ROCK COUNTY COURTHOUSE VAULT ALTERATION - ADDENDUM No. 01

ISSUE DATE: February 27, 2023

PROJECT NAME: Rock County Courthouse Law Library Alteration

PROJECT NUMBER: 210105.00

Sheet 2 - A100

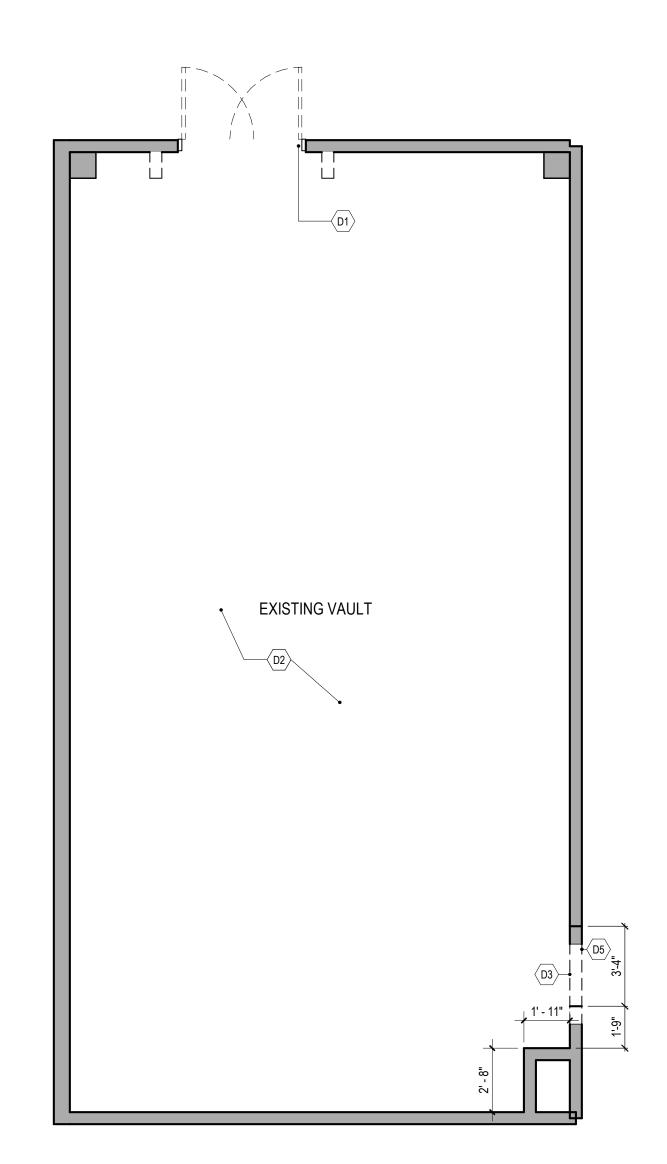
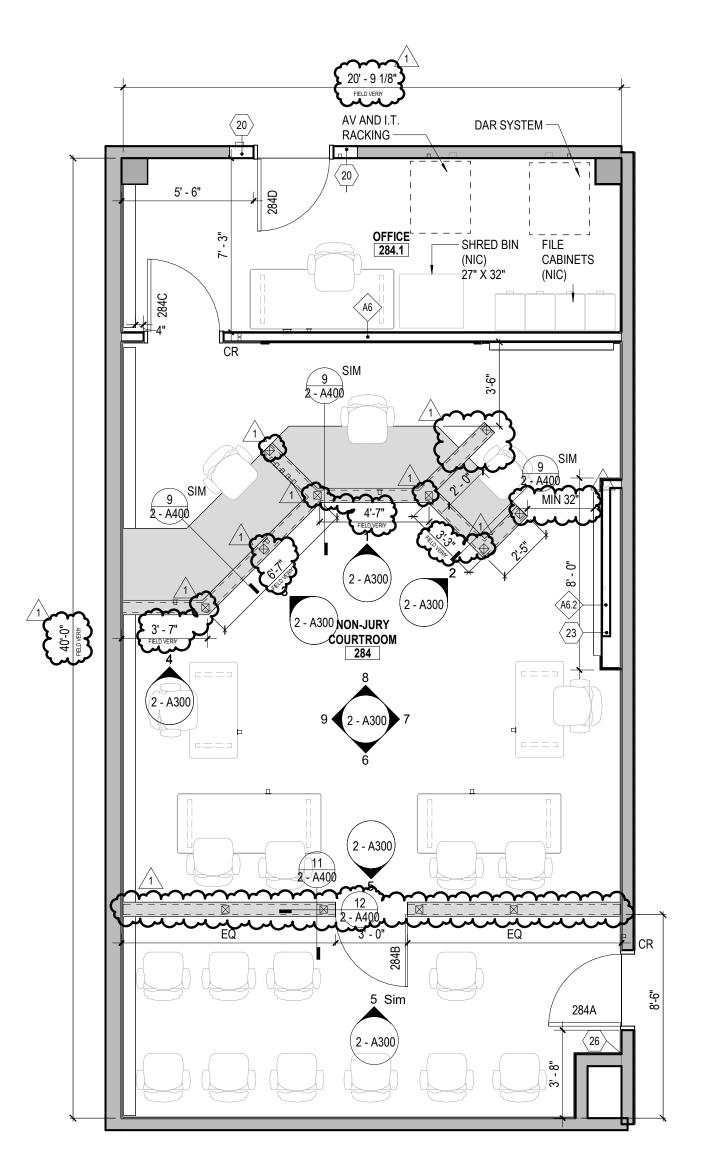
- 1) Sheet 2-G100 COVER SHEET / INDEX / LIFE SAFETY PLANS
 - a) NOTED revised sheets
- 2) Sheet 2-A100 DEMOLITION PLANS AND FLOOR PLANS
 - a) REVISED locations of gallery rail support posts

- b) REVISED location of east wall
- c) REVISED dimensions of Commissioner's Bench
- d) REVISED location of monitor on north wall
- 3) Sheet 2-A200 REFLECTED CEILING PLANS

THIRD FLOOR - CEILING PLAN

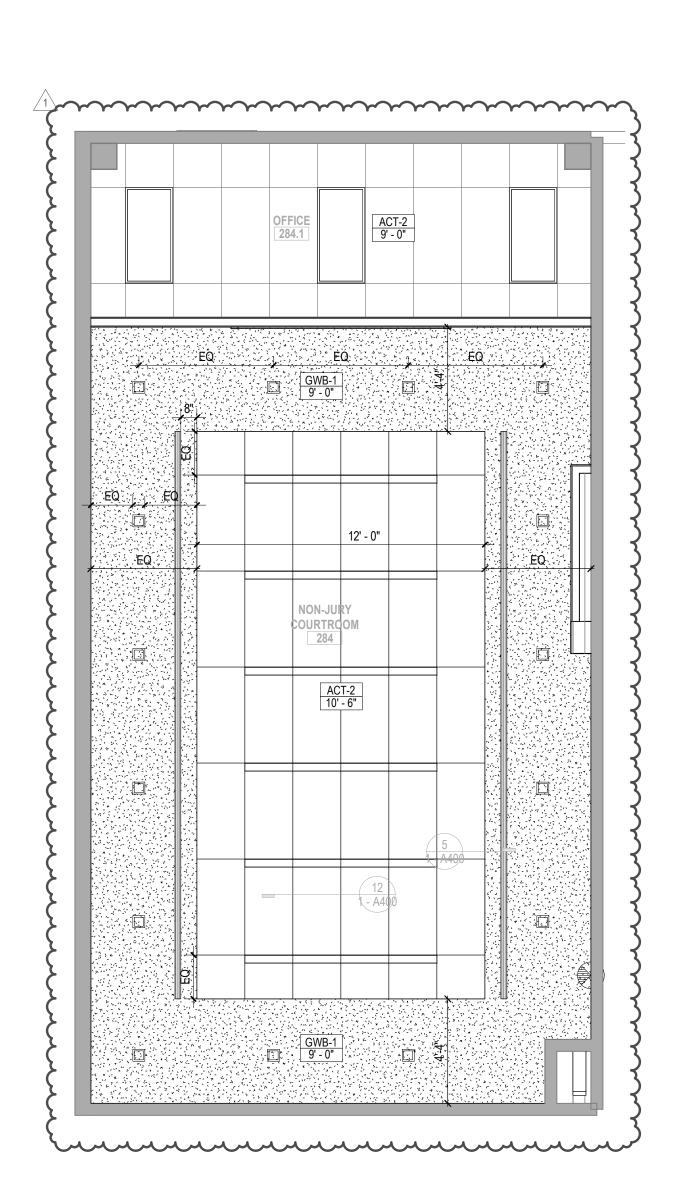
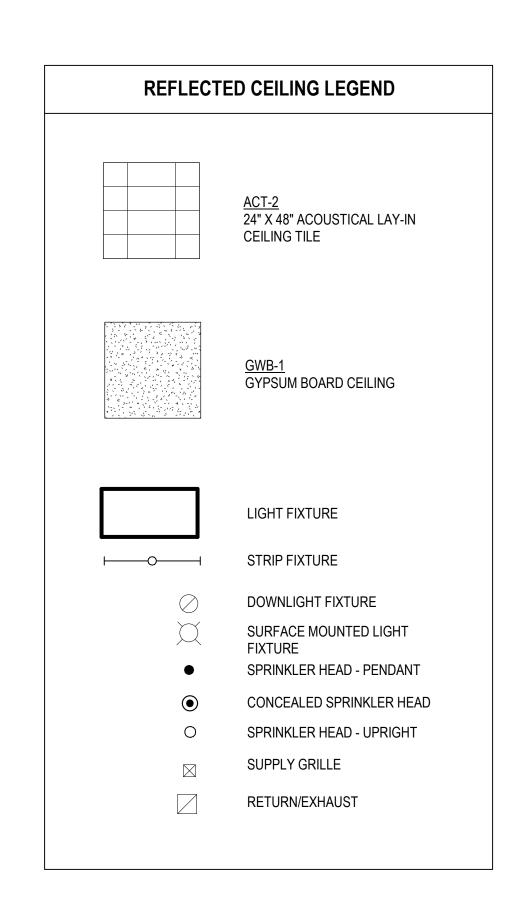
- a) REVISED location of east wall
 - b) REVISED soffit dimensions
 - c) REVISED location of recessed ACT ceiling
- 4) Sheet 2-A300 INTERIOR ELEVATIONS
 - a) REVISED North Elevation to show individual panel dimensions

Sheet Number 2- M100

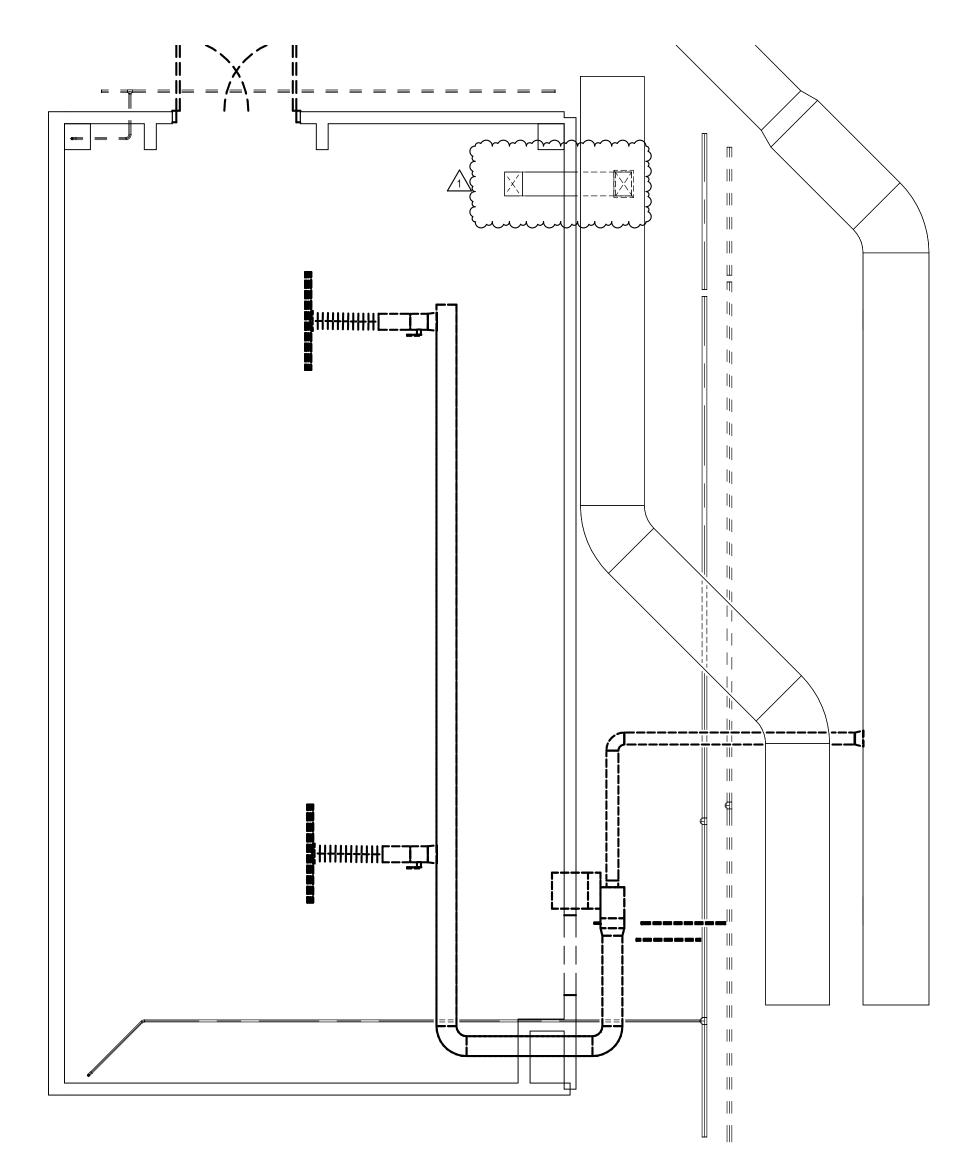
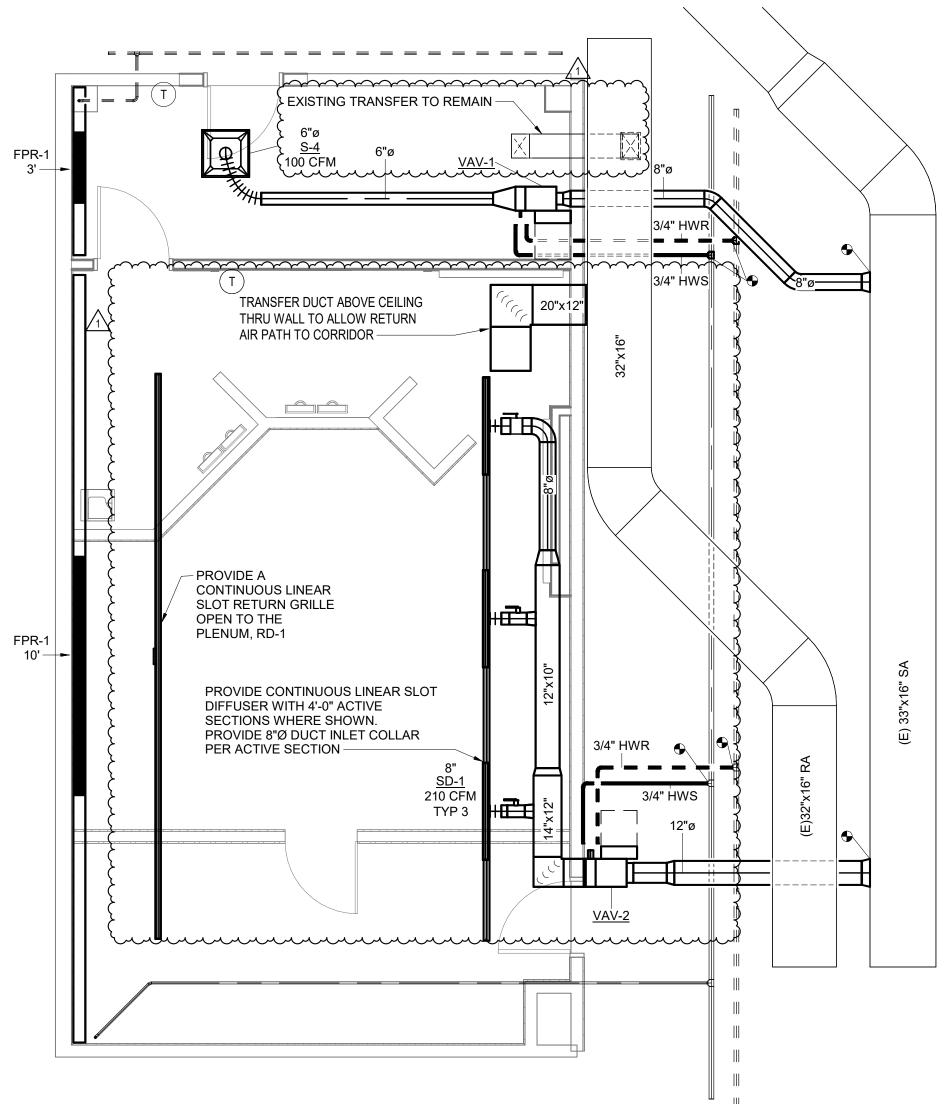
- d) REVISED detail 10 callouts to reflect details 11 and 12
 - e) ADDED detail 11
 - f) ADDED detail 12
- 6) Sheet 2-M100 FOURTH FLOOR MECHANICAL PLAN
 - a) REVISED location of linear slot supply diffuser.

- b) REVISED supply ductwork to match updated diffuser layout.
 - c) REVISED demolition of existing transfer to existing to remain.
 - d) REVISED return ductwork in office to be non-ducted.

- e) DELETED return ductwork serving courtroom.
 - f) ADDED transfer duct serving courtroom.
 - g) ADDED note to clarify supply and return linear slot.
 - h) ADDED view #3 "Fourth Floor Supply Ductwork Section".

- i) ADDED note to clarify demolition.
- 7) Sheet 2-M600 MECHANICAL SCHEDULES
 - a) REVISED Slot and Linear Bar Diffused Schedule
